TRI-PARTY AGREEMENT

Change Notice Number TPA-CN- 700	TPA CHANGE NOTICE FORM	Date: 11/17/15
Document Number, Title, and Revision: DOE/RL-2014-13-ADD2, Remedial Design Report/Remedial Action Work Plan Addendum for the 300 Area Groundwater, REV. 0 1229943		Date Document Last Issued: June 2015
Originator: Patrick A. Baynes		Phone: 509-372-3583

Description of Change:
Figure 7-1, Schedule for Groundwater Remedy Implementation, is being replaced with an updated schedule.

Figure 7-1. Schedule for Groundwater Remedy Implementation

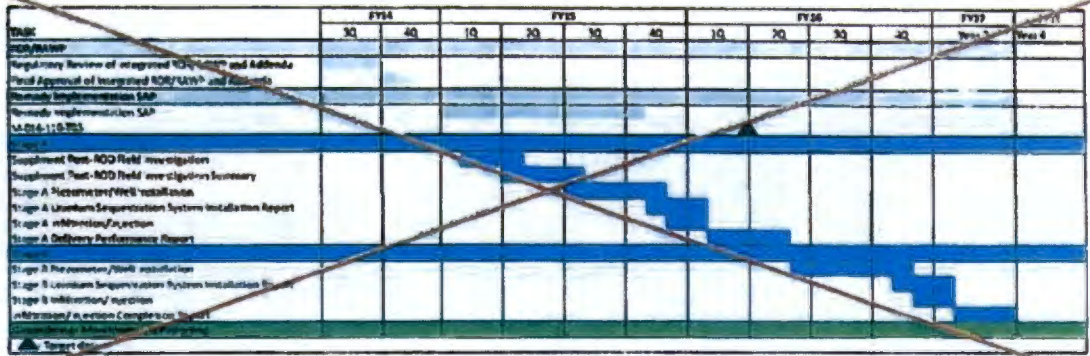
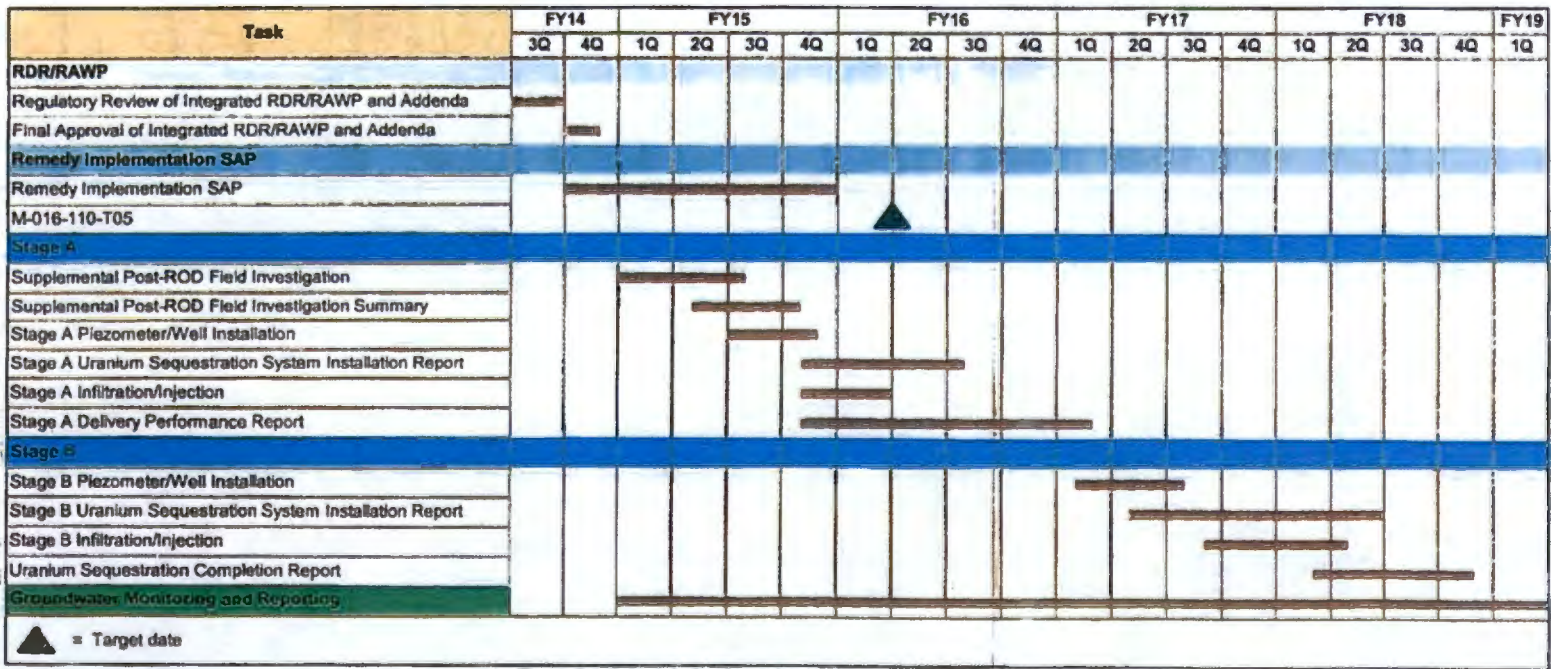
Figure 7-1 on Page 7-2 is being replaced with a new figure to reflect the following changes:

- Stage A Uranium Sequestration System Installation Report - the effort to prepare and issue this report is expanded from a 3 month effort to be finished in the first quarter of FY 2016 to a 9 month effort to be finished in the third quarter of FY 2016.

- Stage A Delivery Performance Report - the effort to prepare and issue this report is expanded from a 4 month effort to be finished in the first quarter of FY 2016 to a 16 month effort to be finished in the first quarter of FY 2017.

- Stage B Piezometer/Well Installation - the Stage B uranium sequestration implementation is delayed from FY 2016 until FY 2017.
- Stage B Uranium Sequestration System Installation Report - the effort to prepare and issue this report is expanded from a 5 month effort to be finished in the first quarter of FY 2017 to a 14 month effort to be finished in the second quarter of FY 2018.

- Stage B Infiltration/Injection - the Stage B uranium sequestration implementation is delayed from FY 2016 until FY 2017. This activity also includes demobilization.

- Uranium Sequestration Completion Report - this report is delayed from the fourth quarter of FY 2017 to the fourth quarter of FY 2018.

Justification and Impacts of Change:
The schedule duration for preparation and issuance of the Stage A Delivery Performance Report is being changed to better reflect the time required to obtain the necessary data for the report. Three (3) boreholes will be drilled and sampled 4 weeks after the final injection. The samples will be analyzed for uranium and leachability. The leachability testing takes ~110 days. The analysis results will be used to generate the final 3-D STOMP model which will take - 20 days. The 3-D STOMP model will be used to support preparation of the report. The report will then go through the typical document review and approval process which takes - 90 days. The Stage B uranium sequestration implementation is being deferred until FY 2017 due to site priorities. The schedule duration for preparation and issuance of the Uranium Sequestration Completion Report is being changed consistent with the discussion above.
